A G E N D A

Architectural Review Board

August 23, 2016

Fiberglass Column
 Detail

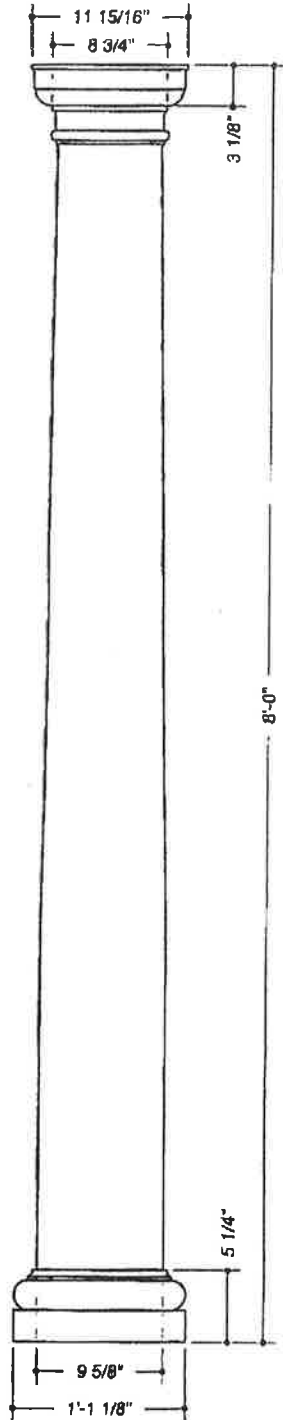
- We discussed the issues of authenticity and longevity on site, given the significance of the resource. They have been advised care should be taken with introducing an impermeable column (fiberglass) against the wood railing.
- The Board has previously approved fiberglass columns.

805 Cloverdale Road

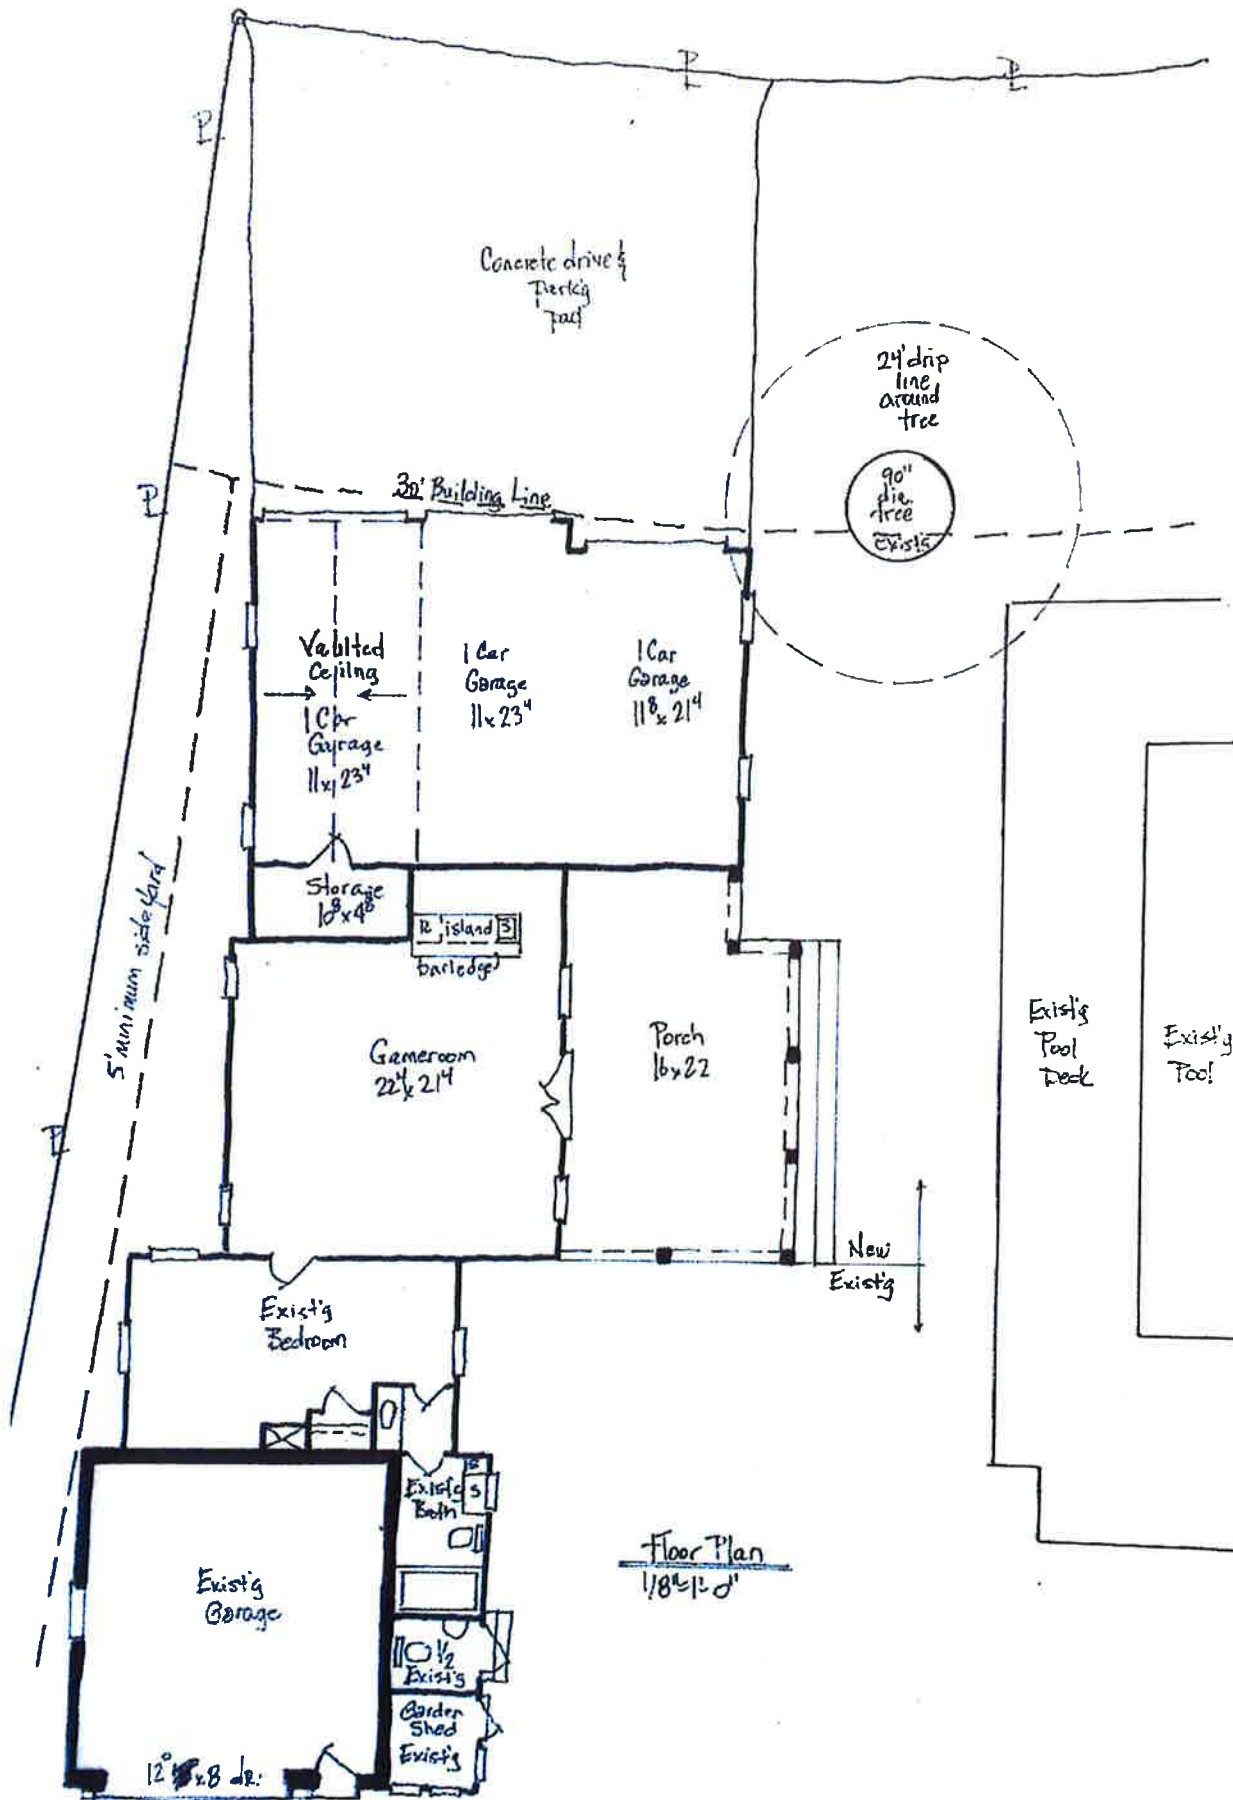
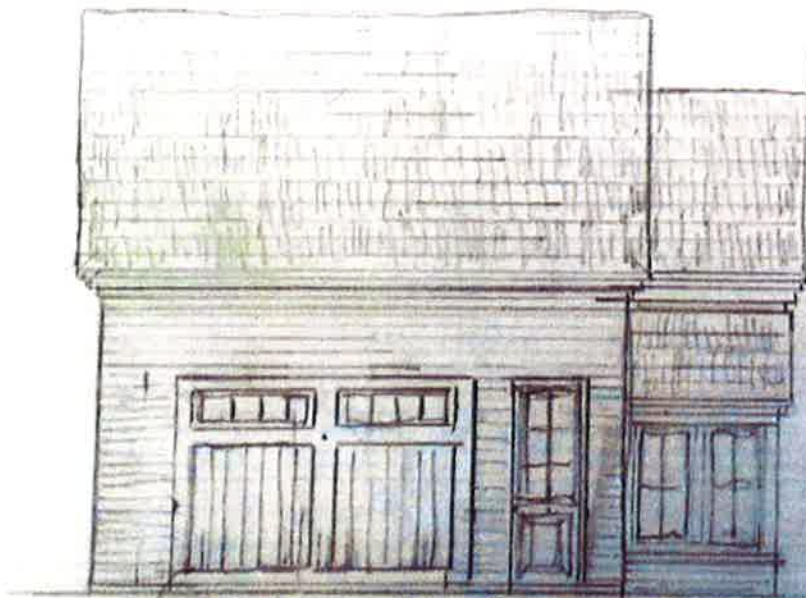
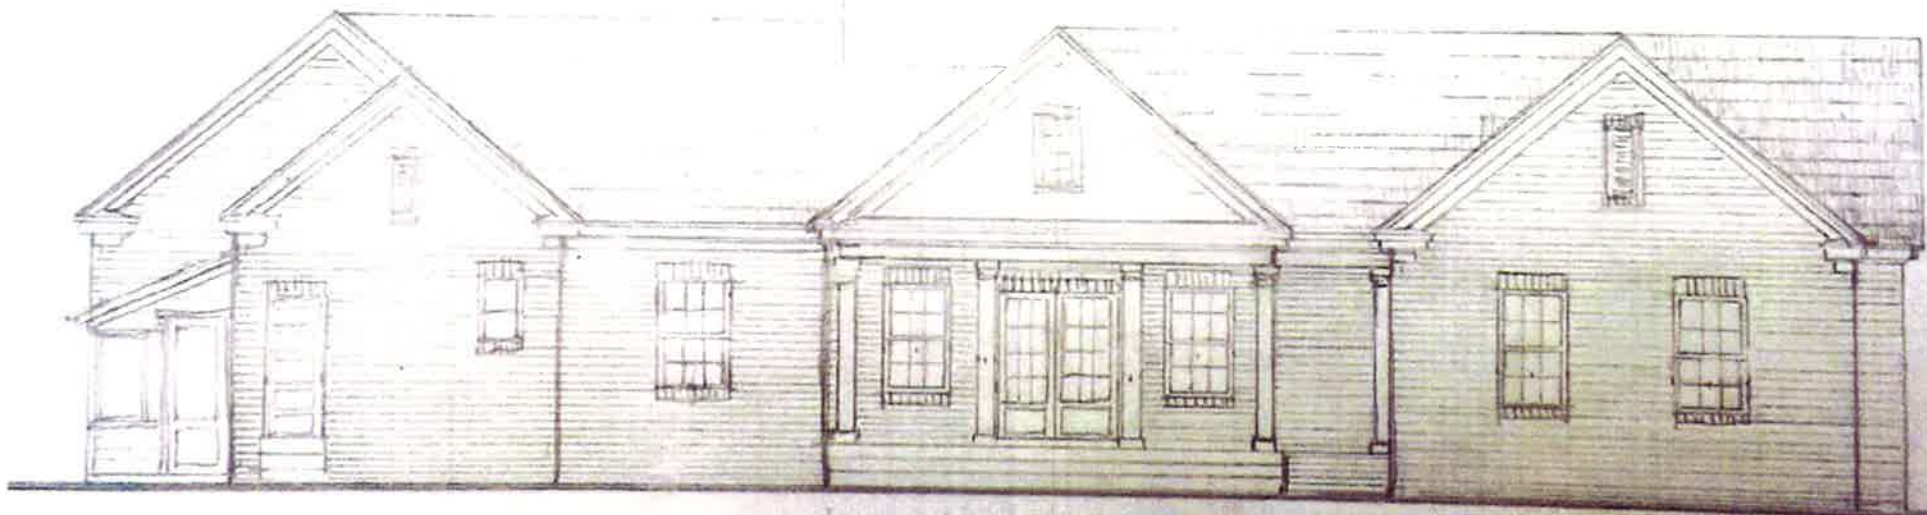
- The property is one of the larger estate lots in Cloverdale. The Board needs to consider if the proposed addition is appropriately scaled and whether it detracts from the overall historic character of the property or district.

EXTERIOR ELEVATIONS

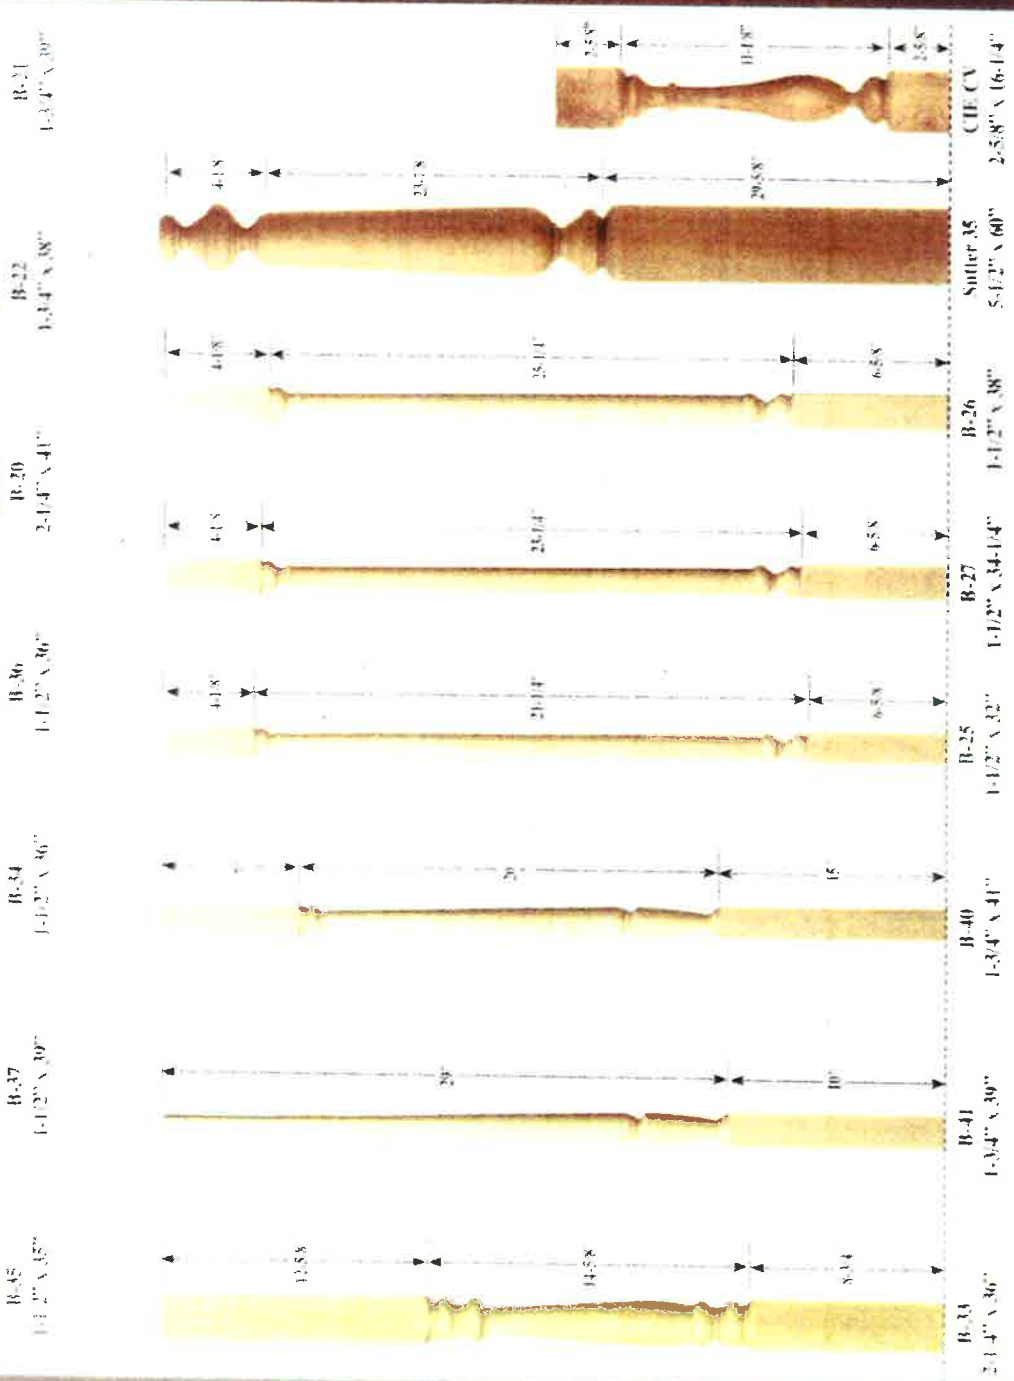
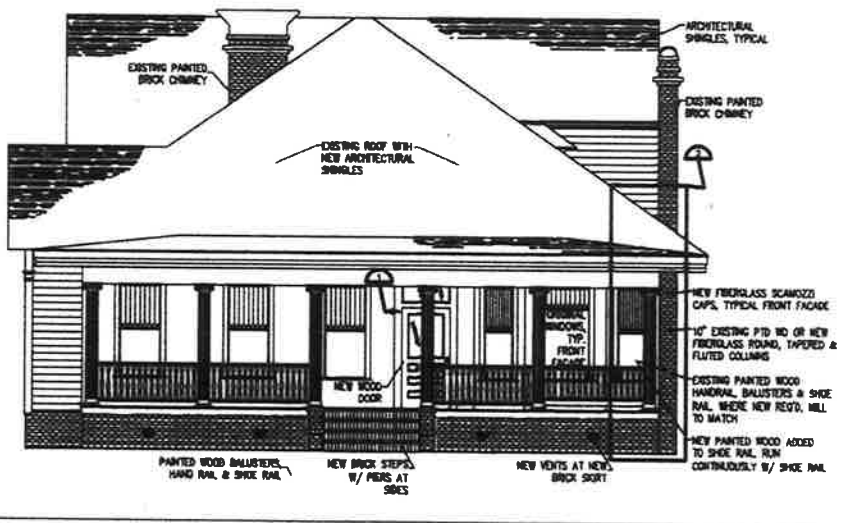
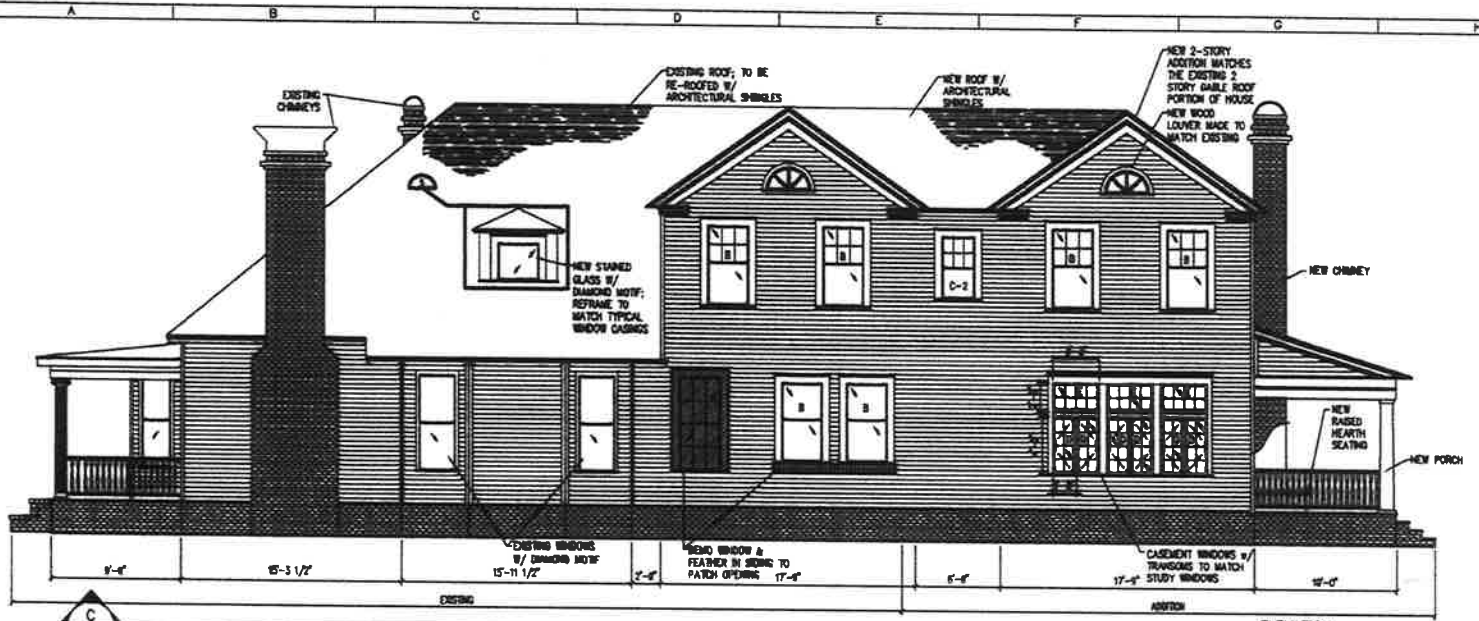
- The Board has previously approved fiberglass columns.
